## Clarks Creek TMDL Implementation Plan - 2021 Update Response to Ecology's Comments - Pierce County Edits

**DATE:** July 15, 2002

**FROM:** Tim Hagan, Pierce County, Surface Water Management

**TO:** Sheila Marco, SWRO Supervisor, Watershed Resources Unit

**Ecology provides these comments on Appendix B - Technical Memorandum:**

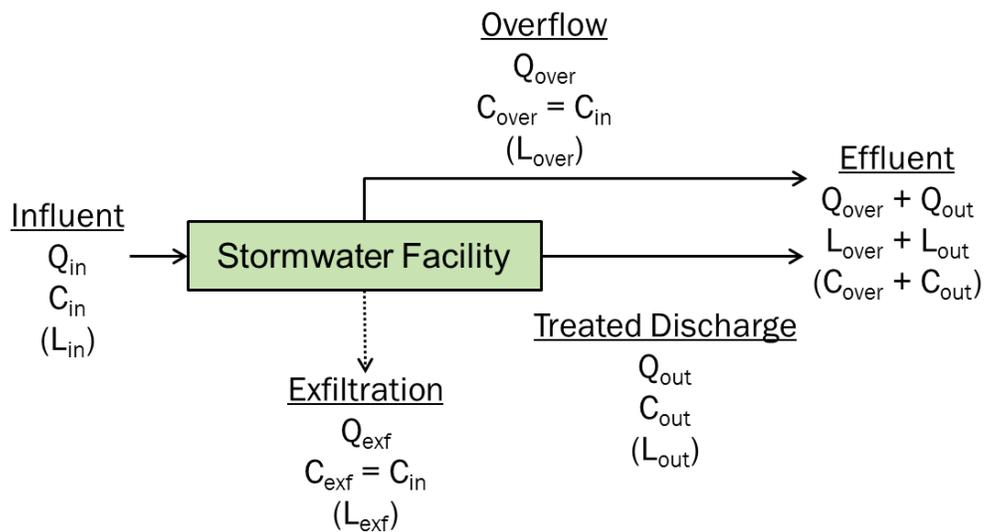
Appendix B of the 2021 Plan was not updated to include the treatment wetland that replaced the 104th Street E pond.

**Ecology Recommended Edit (Appendix B, pg. 39):** Please update Appendix B to reflect this replacement of the 104th Street E pond with a treatment wetland. Please describe the method for crediting this treatment wetland in Appendix B. Tables 6 and 7 in Appendix B still refer to the 104 Street E Pond.

**Pierce County Response (Appendix B, starting pg. 39):**

**County Response: Swales and Treatment Wetlands.** The two bioswales, Canyon Creek PDD-east basin and Wysteria Condominiums, were designed for runoff treatment but not detention. For those 2 projects, a rating table was developed that included a calculation of Hydraulic Residence Time (HRT) for increasing volumes, flow rates, and velocities through the swale or wetland. Ecology standards require a minimum HRT of 9 minutes for effective treatment in swales and wetlands (SWMMWW Volume V, Ecology 2014a). At each time step, the rating table was used as a lookup table, where HRT was interpolated from looking up the inflow flow rate and compared to the 9-minute threshold.
